Re: King I Mine, C-1981-035
Stoner Engineering: Quarterly Inspection: Water Quality Improvements
3rd Quarter 2017

Re: King Coal I – Quarterly Water Quality Improvements Inspection

Pic. 1 – East pond, fill material installed in base, no sediment gage.

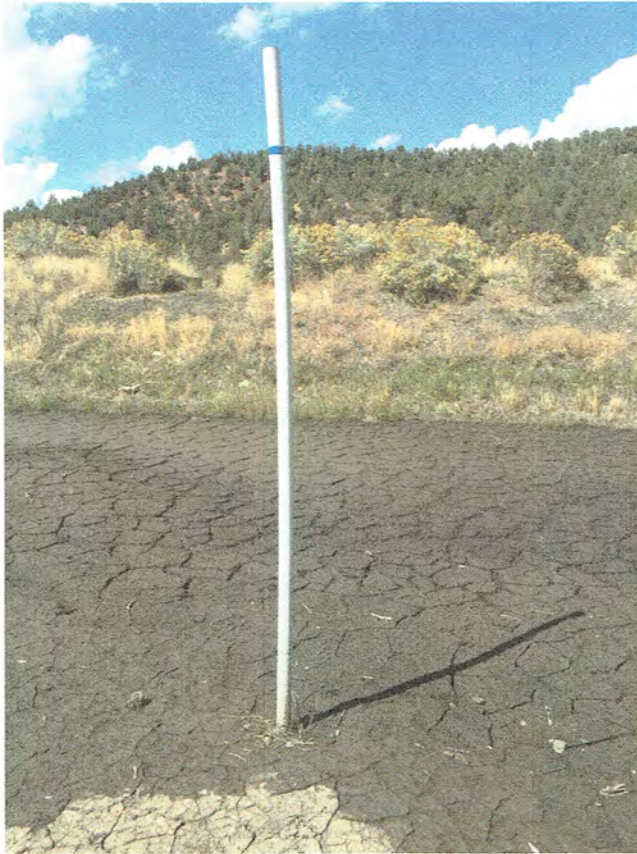
Both ponds were dry at the time of the inspection. The east pond was undergoing some work at the time of the inspection (see Pic. 1 & 2). The bottom of the east pond has been raised though the exact amount is unknown. It appears that the work on the east pond is not complete though the pond will still accept site runoff. The results of the construction and survey should be forwarded as soon as the work is completed. As-built survey will be required to set proper gage level for sedimentation levels. The markings on the sediment gage for the west pond have come off though the location is still visible (see Pic. 3). The gage should be repaired to show the maximum sedimentation level so ensure the proper maintenance schedule is followed. The ponds are both in generally good condition. The required storage volume appears to be adequate at this time based upon the sedimentation gage installed in the west pond and the visual volume of the east pond (currently no sedimentation gage). The sedimentation levels of the ponds should be checked after the existing water dissipates from the ponds. The ponds should continue to be monitored after storm events to ensure that excess sediment does not reduce the required storage capacity available for storm water runoff.
